Application for Works Approval

Works Approval Number W6610/2021/1

Applicant Nationwide Oil Pty Ltd

Premises Nationwide Oil Pty Ltd
28 Kenwick Road
MADDINGTON WA 6109

Figure 1: Proposed site plan and infrastructure

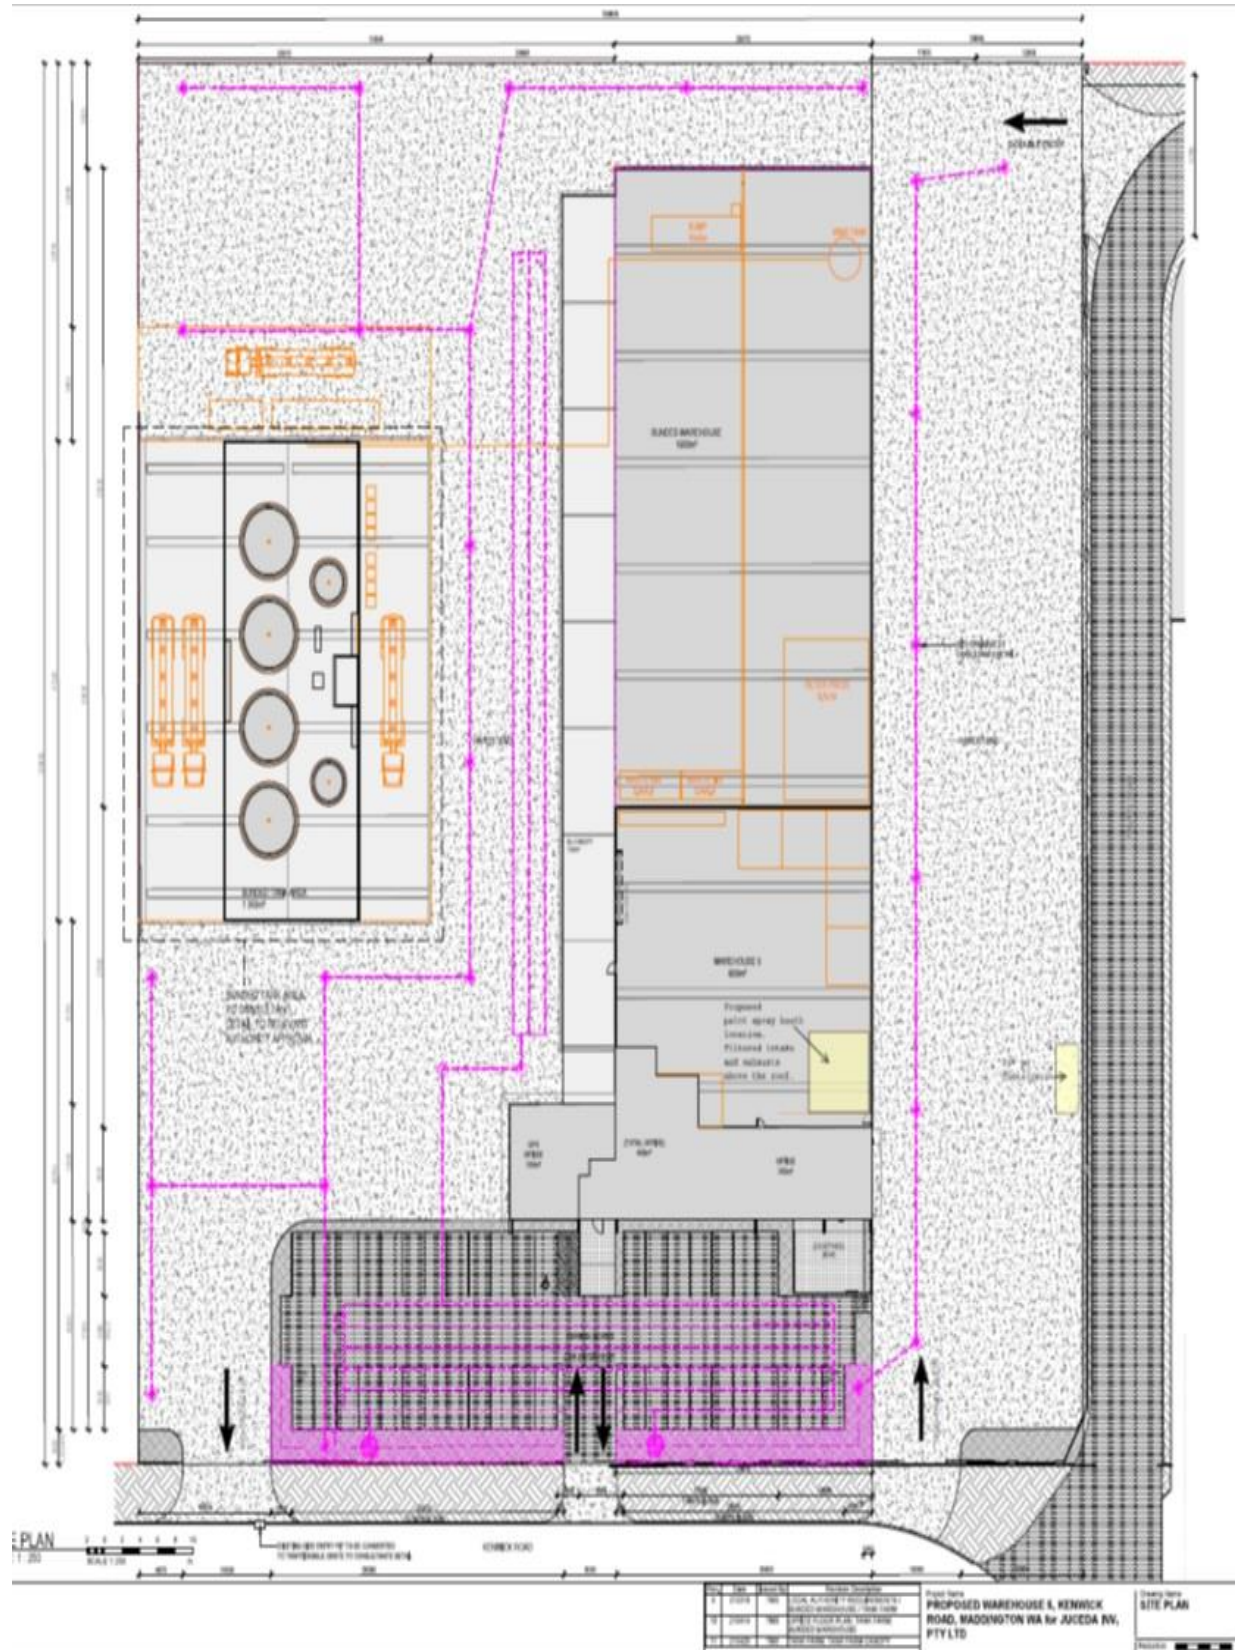
Condition	Summary of applicant's comment	Department's response
	wastes from being stored in the Workshop and Bunded Warehouse.	
Condition 14, Table 6 Units	Cleanaway requests that waste accepted onto the premises is recorded in litres (not m ³) and tonnes to be consistent with controlled waste tracking documentation requirements.	Table 6 has been updated
Condition 15, Table 7 Units	Cleanaway requests that waste removed from the premises is recorded in litres (not m ³) and tonnes to be consistent with controlled waste tracking documentation requirements	Table 7 has been updated
Schedule 1: Maps Figure 3: Proposed tank farm	An updated version of the figure is provided in Attachment B. The same figure can be used to update Figure 3 of the decision report.	Figure 3 has been updated
